Our ref: DOC24/387833  
Your ref: SSD-33083358

**Subject: Moolarben OC3 Extension Project – Response To Submissions (SSD-33083358)**

Attachment B – BCS's Review of the Response to Submissions

### Moolarben OC3 Extension Project – Response to Submissions

**Figure 1: Snip of vegetation mapping presented as part of the BDAR**

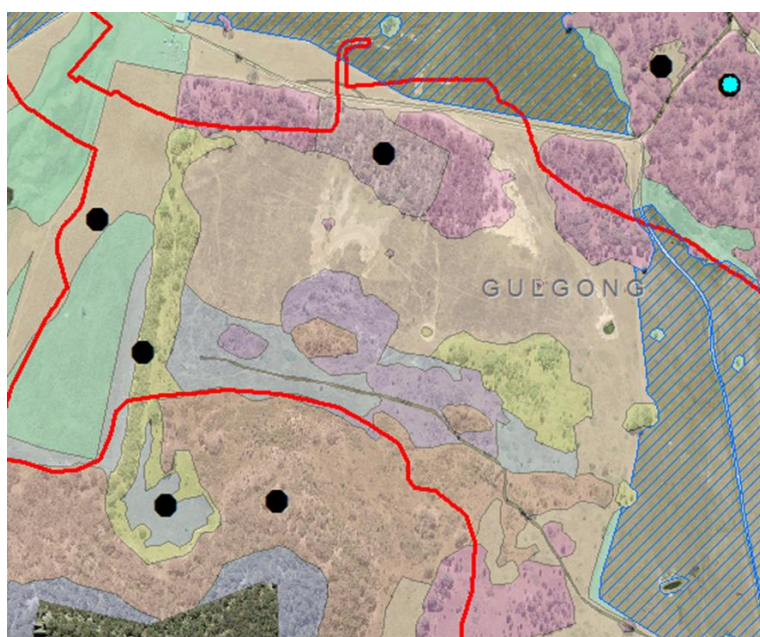
We note that there are numerous vegetation patches throughout the development footprint that have been allocated to a PCT and condition class to form a vegetation zone or part of a vegetation zone, however there are no plots within the patch (see Figure 1 below).

Figure 1 shows a number of vegetation zones (coloured shading) that do not contain any plots. It is unclear how these areas were delineated into vegetation zones.

- 37 Provide evidence to clarify how areas of PCTs where there are no plots were delineated into vegetation zones.
- 38 Provide further information about the Habitat Enhancement Area project to BCS for review and comment prior to approval.
